RE: Declaration in accordance with Section 5 of the Planning & Development Acts
2000 (As Amended) – EX54/2023

DECLARATION IN ACCORDANCE WITH ARTICLE 5 (2) (A) OF THE PLANNING & DEVELOPMENT ACT 2000 AS AMENDED

Location: 7 Prince of Wales Terrace, Bray, Co. Wicklow

Reference Number: EX 54/2023

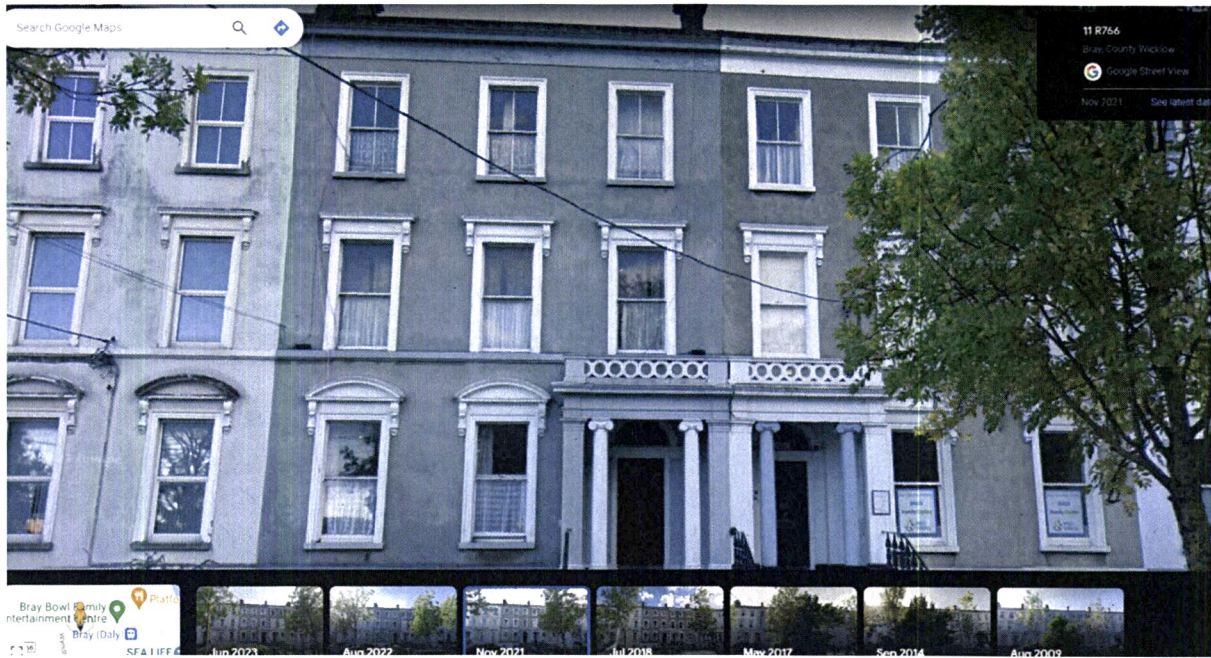
The works relate to the alteration of the protected structure and an act involving the removal and replacement of the windows from the front exterior of the building. It is considered that ‘development’ has taken place.

However, given that the proposed development relates to a Protected Structure, Section 57(1) of the Planning and Development Act 2000 (as amended) is also applicable. In this regard, Section 57 (1) states “*Notwithstanding section 4(1)(a), (h), (i), (j), (k) or (l) and any regulations made under section 4(2), the carrying out of works to a protected structure, or a proposed protected structure, shall be exempted development only if those works would not materially affect the character of – (a) the structure, or (b) any element of the structure which contributes to its special architectural, historical, archaeological, artistic, cultural, scientific, social or technical interest*”. The question therefore arises as to whether the proposed works would materially affect the character of the protected structure or any element of the structure which contributes to its interest.

Works that might ordinarily be exempt, are not exempt by reason of Section 57, if the works materially affect the character of the structure or element of the structure which contributes to its special architectural interest.

The original timber windows significantly positively contribute to the appearance and architectural interest of the protected structure. The replacement of the original timber windows with the upvc windows does materially affect the appearance and character of the protected structure. The proposal to retain these upvc windows on the lower floors materially affects the character of the structure and therefore is not exempted development. The proposal to replace the upper windows with two over two pane upvc sash windows would materially affect the appearance and character of the structure and therefore is not exempted development.

- The original timber windows significantly contribute to the appearance and architectural interest of the protected structure. The removal of the original windows and replacement with upvc windows does materially affect the external appearance and special architectural interest of the of the structure and therefore materially impacts on the character of the protected structure. The proposal to retain these upvc windows on the lower floors materially affects the character of the structure and therefore is not exempted development. The proposal to replace the upper windows with two over two pane upvc sash windows would materially affect the character of the structure and therefore is not exempted development. The works are not exempted development under Section 57.

is development and is **not** exempted development
